May 2, 2023

Subject: Proposed Rule amending environmental protection regulations pursuant to Revision 2 to NUREG-1437 "Generic Environmental Impact Statement for License Renewal of Nuclear Plants" (LR GEIS)

Turkey Point Nuclear Power Plant's Site-Specific Environmental Impacts

Figure 1: March 8, 2023 salinity event on L-31E canal, at approximately 3:00AM. Source: Miami-Dade County Department of Regulatory and Economic Resources.

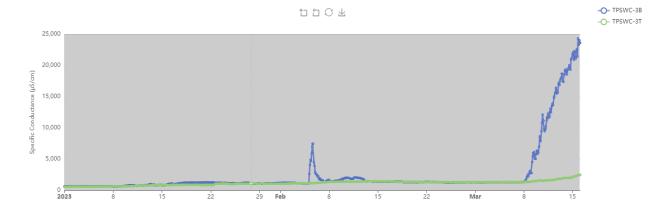
Under current authorization, water is taken from the brackish Floridan Aquifer and pumped into the CCS.¹⁹ However, no matter the source of the water used to freshen the canals, there exists the possibility of a decreased or reversed piezometric head gradient if the CCS water level exceeds the stage of the L-31E, resulting in advection of hypersaline water into the L-31E. Figure 1, below, shows measured spikes in specific conductance indicating that significant salinity events in the L-31E have occurred as recently as March 2023.

This issue must be modified from a "1" to a "2" and significance should be elevated from "small" up to "moderate/large". As noted above, Miami-Dade County has documented salinization events on the L-31E canal that may be caused by cooling canal water augmentation. The L-31E, a freshwater canal, discharges water to the Biscayne Bay Aquatic Preserve. The waters of the preserve are historically estuarine, and life is adapted for estuarine conditions less saline than marine waters.

Any review of a future license extension should consider hydrological interactions between the cooling canal system, the L-31E, and any nearby control structures. If operation of the CCS is causing salinizing events to occur outside of the cooling
